MEMORANDUM – PLAN & DESIGN COMMISSION

RE: **Public Hearing #2023-SPE-001 for a Special Exception and Design Review application for a proposed parking lot, with relief to off-street parking regulations, landscaping, lighting, and other variations (700 Park Avenue W, 678-696 Park Avenue W, and 668-670 Park Avenue W)**

SUNSET PARK APARTMENTS
 Parking Lot Addition - Frontyard Option
 668 - 700 Park Ave West, Highland Park, IL

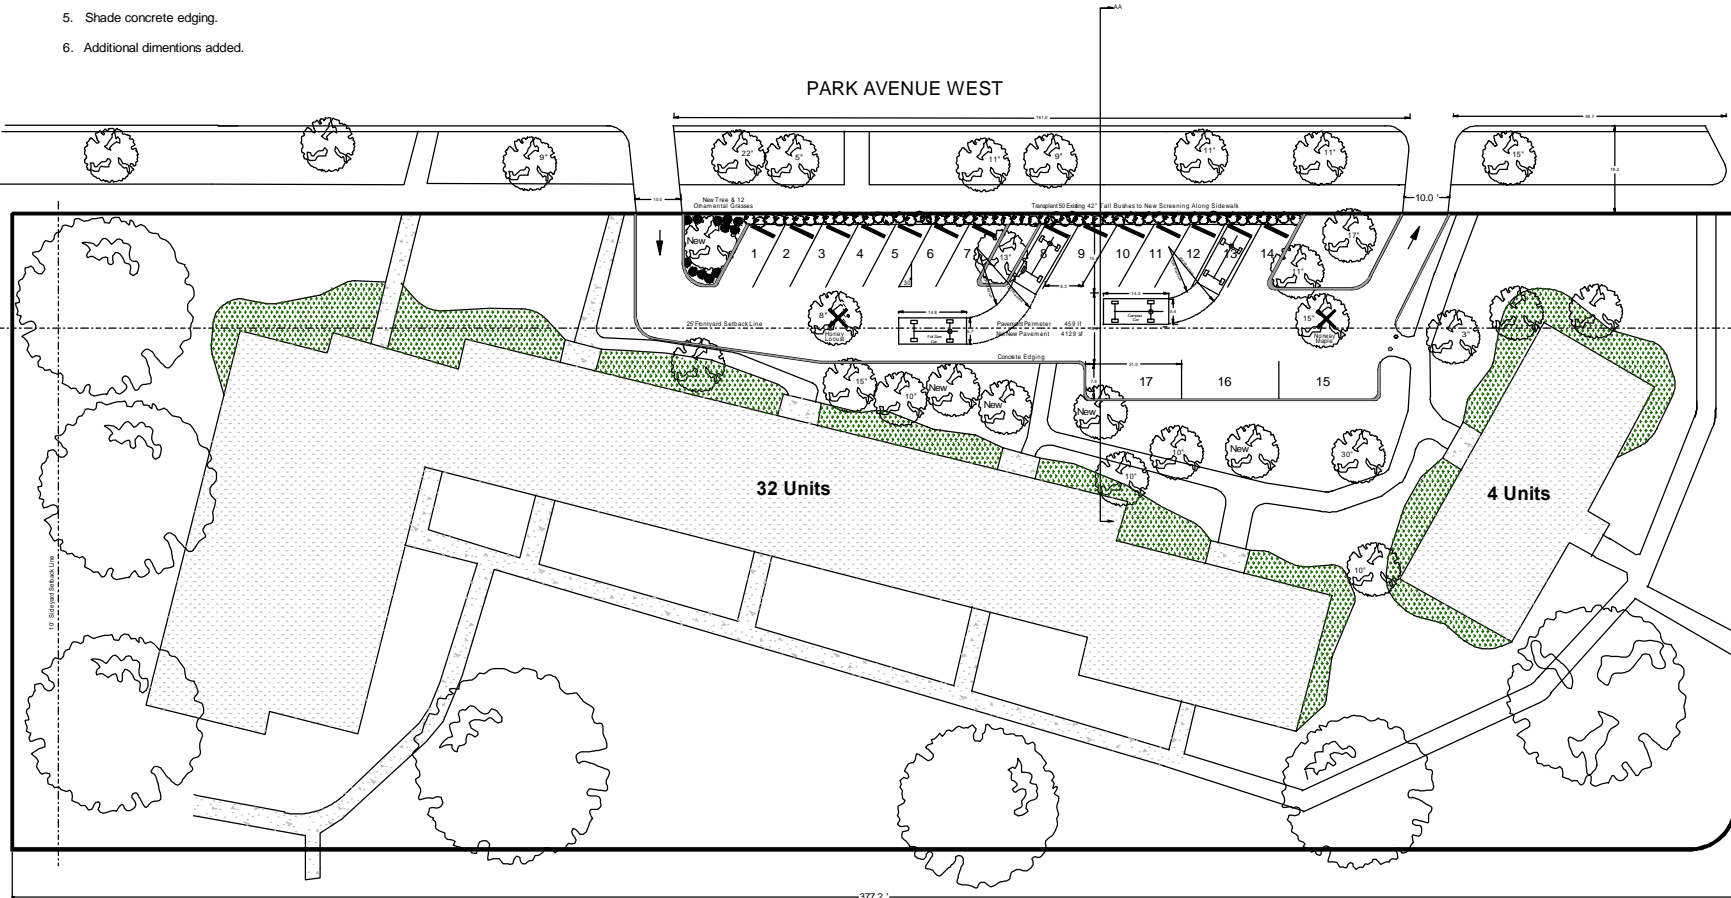
The PDC considered this application at its February 21, 2023 meeting and provided comments to the Applicant. That meeting packet, minutes (if available), and video are available online [here](#). The PDC continued the item to its March 21 meeting by vote 7-0. No public spoke at the meeting, nor have submitted any written comments. In summary the PDC discussed the following (non-exhaustive list and not meant to be verbatim):

1. Discussion of bumper stops.

2. Discussion of distance to east driveway.
3. Consider fencing versus landscaping screening on the front.
4. Must show full-size car turning movements.
5. Need more space for parallel parking spaces.

- a. **RELIEF REQUESTED.** ~~Applicant proposes 8' width parking spaces and 16' long projections. The aisle width is 14'.~~
 - i. UPDATED: Applicant proposes 14 sixty degree parking spaces with 8.25' widths and 15.4' projections. The 8.25' width is acceptable if the off-street parking lot is lower-turnover, per Section 150.808.D.2 Note 4.b. Note that the regular requirement for width, without the exception, is 9.83'. The 15.4 projection does not meet the 18.75' projection required – **relief of 3.35' for 14 sixty degree parking spaces.**

- ii. UPDATED: Applicant proposes three parallel parking spaces with 7.5' widths and 21' projections. That does not meet the 8.5' width and 22' projection requirement – **relief of 1' for width and 1' for project for three parallel parking spaces.**

- iii. UPDATED: The drive aisle for 60 degree parking must be 16.5', with a one foot reduction allowed per Section 150.808D.2. Note 4.b., or 15.5' requirement. The Applicant proposes 15.4', **or relief of 0.1'.**

- iv. UPDATED: The Applicant does not depict any ADA spaces. One is required per Section 150.808.E. The State ADA requirement cannot be waived nor varied. The Applicant will lose one parking space as the space adjacent the ADA space must be striped and left open pursuant to the regulations of Section 150.808.E.

1. **RELIEF REQUESTED.** A 5' buffer is required abutting the perimeter of the parking lot within the front 25' of the property. A non-dimensioned buffer is proposed.
2. The Applicant proposes landscaping abutting the perimeter and a tree island is required, per Section 150.2220.C, and is proposed along the north parking aisle.
3. **RELIEF REQUESTED.** The Applicant should provide an inventory and landscaping plan to verify what shrubs and trees are being planted, the species, and install heights (to comply with [Section 150.2230](#)).

UPDATED: The Applicant's revised Site Plan in **Attachment 2** depicts 50 42" (inches) tall bushes and five new trees. No caliper, height, or species information is provided for the trees. No species information is provided for the bushes. See the review of landscaping further in this report.

The Applicant has changed the site plan from a single entrance, two-way driveway aisle with turnarounds, and 19 total 90 degree parking spaces (see Attachment 2 from the February 21 packet) to the proposed site plan in **Attachment 2**. The project now depicts 14 sixty degree parking spaces and three 90 degree parking spaces, or 17 total spaces, with a one-way in and one-way out entrance/exit setup (with one-way drive aisle). A landscaping island is proposed. Turning movements for compact and full size car are depicted on the site plan.

The site plan includes bumper stops. The 60' distance requirement of Chapter 93 is met, both onsite and to the eastern school driveway, no fencing is depicted (Applicant has maintained bush plantings along the north buffer), movements are depicted included full-size car, and parallel parking spaces are 4.5' longer in projection than those submitted at the February 21 PDC meeting (and not included in the PDC packet)².

Rev 3.1 Notes:

- 1. Remove one parallel space. Make remaining 3 +/- 21 ft long.
- 2. Increase width of angled parking to 8' - 3" (Same as Central Ave Lot).
- 3. Note 30 angle on angled parking space.
- 4. Show standard car size turning radius.
- 5. Shade concrete edging.
- 6. Additional dimensions added.

SUNSET PARK APARTMENTS
 Parking Lot Addition - Frontyard Option
 668 - 700 Park Ave West, Highland Park, IL

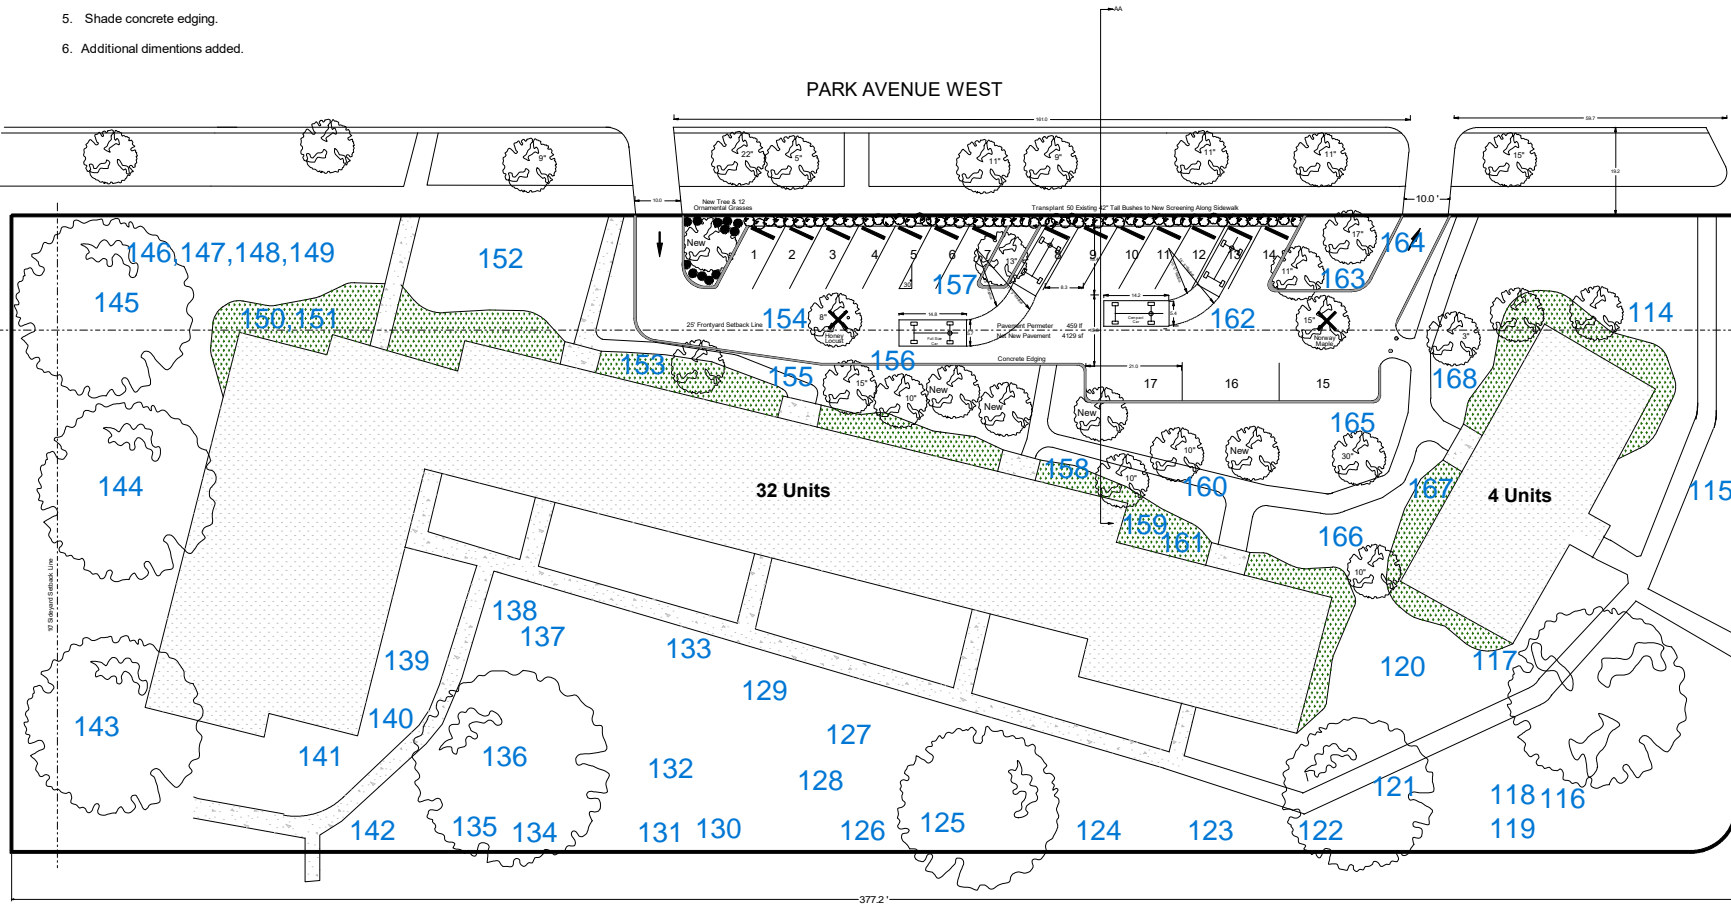
- Commission comments (summary only – see video at link for full comments):
 - Overhang into property line and landscaping area – consider bumper stops.
Bumper stops will be installed to prevent overhangs.

- Need diagram that shows full sized car turning movements.
Included in the attached drawing.
 - Parallel spots need more space.
One parallel space was removed to make more room for others.
The aisle width was also increased.

- Concern about left hand turn movement out of parking lot and distance between east driveway and school driveway.
Distance between driveways is +/- 60 feet

- Also, please review the staff comments:
 - Provide the angle of parking – what angle are the parking space?
30 Degrees as indicated on the attached revised drawing.

- What is the perimeter of the development – what is the perimeter of the smallest box that will fit around the new, proposed parking lot? This is needed to calculate the landscaping requirement.
Pavement perimeter is 459 feet.

Rev 3.1 Notes:

- 1. Remove one parallel space. Make remaining 3 +/- 21 ft long.
- 2. Increase width of angled parking to 8' - 3" (Same as Central Ave Lot).
- 3. Note 30 angle on angled parking space.
- 4. Show standard car size turning radius.
- 5. Shade concrete edging.
- 6. Additional dimensions added.

To: Karl Burhop – Senior Planner
 From: Ben Miller –City Forester
 Date: March 9, 2023
 Re: 700 Park Avenue West –Parking Lot

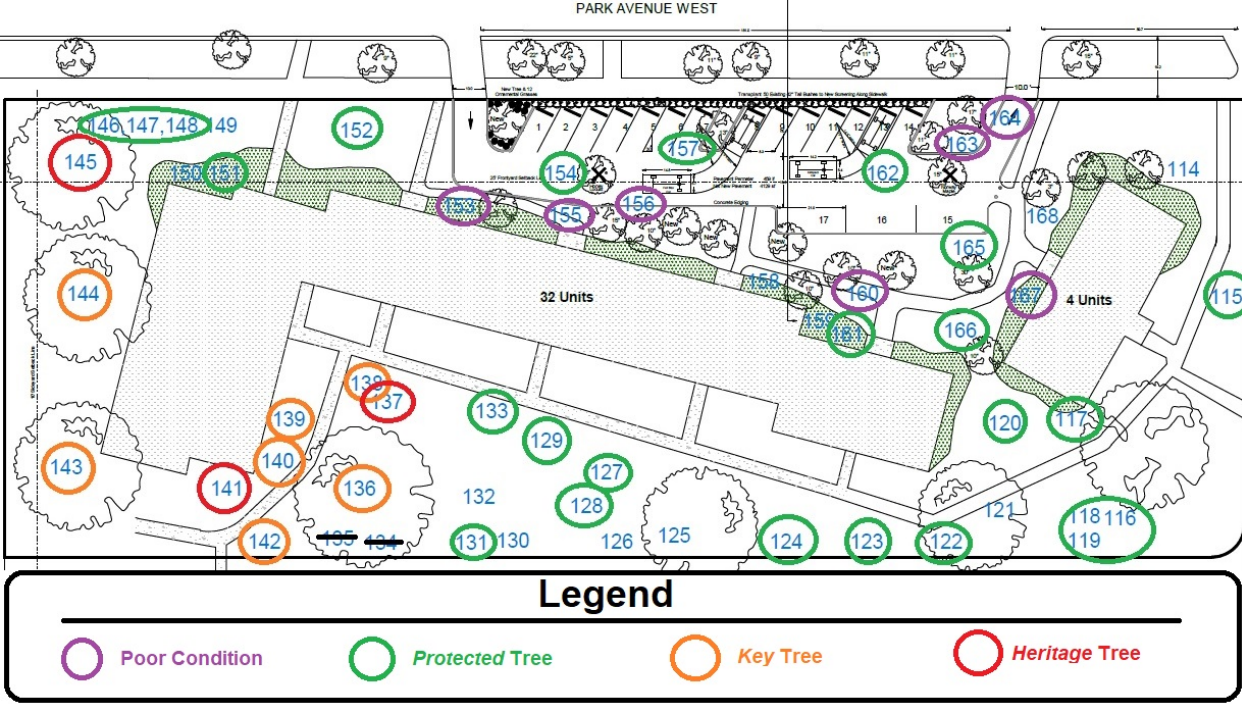
The Forestry Section has been asked to review a revised proposal for a new parking lot at 700 Park Avenue West. This development would be located along the south side of Park Avenue West, north of the existing multi-family residences. Previous drafts of this plan had the parking lot located on the west end of the building. The applicant has worked with Forestry on a revised submittal that takes into consideration the impact on surrounding trees.

The City has received a tree inventory and survey for 700 Park Ave West. Forestry staff has reviewed this documentation and verified the contents in the field. The conclusion being that the relative benefit of locating the proposed parking lot north of the residential complex, as opposed to elsewhere on the site is clear. If such a development is to be approved, from a tree preservation perspective, the logical choice would site these improvements as proposed.

As proposed (and diagramed below), this development would largely require the removal of low-quality trees. This includes infested Ash & Pines, along with a substantial , but failing Honey Locust. Other elements of the landscaping in this area consist of *Protected* trees. No *Key* or *Heritage* trees are in proximity to the proposed construction.

As any other location on this site, would realize a greater impact to surrounding trees; likely including desirable *Key* and *Heritage* trees, Forestry staff supports the proposal.
